Matchanese Mall of Asia

Feedback on Design Proposal #2

Front Signage

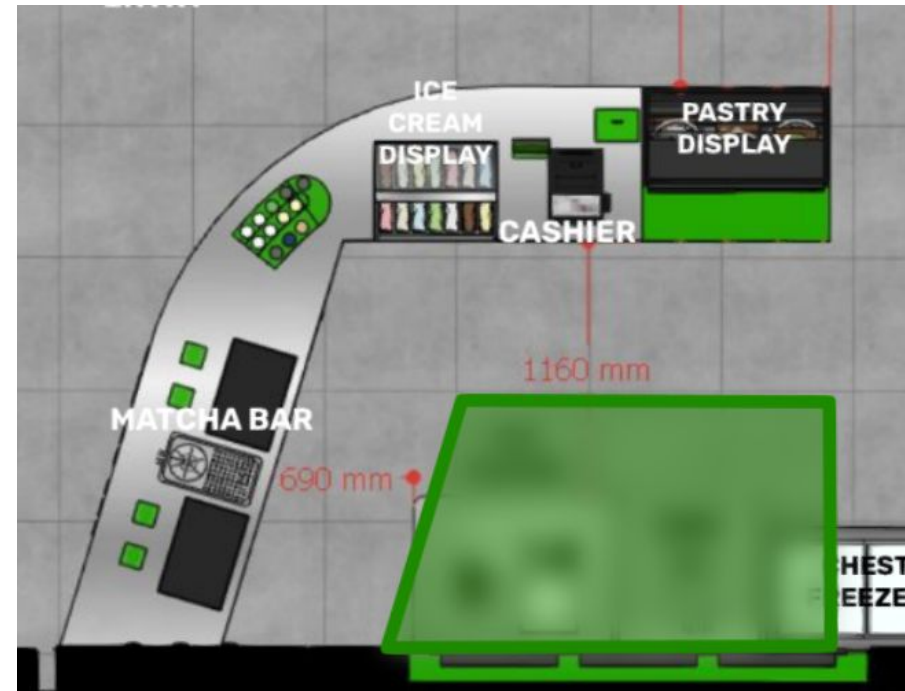
Logo is too big and too tight

Logo must have at least 10% margin from all sides

Logo should be horizontally and vertically centered in reference to the backing element

Since the logomark uses negative space, it must be ensured that the logo is still readable from different angles and there is enough contrast from the backing element

Matchanese Logo Wall

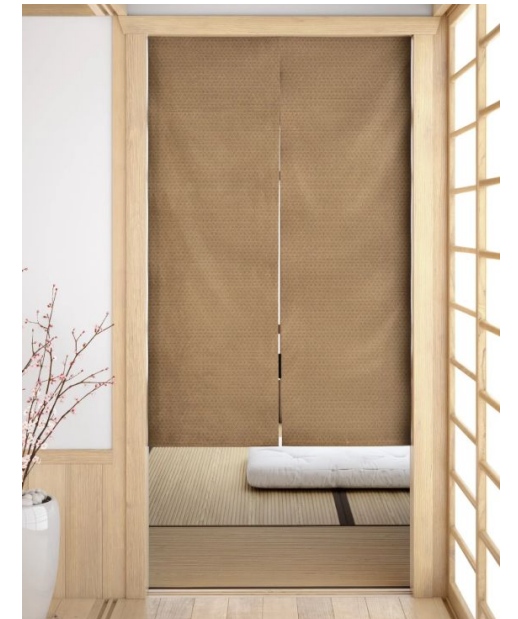
- Looks redundant when looking from the outside since there's already a full logo
- **Place the merch area/shelves here instead**
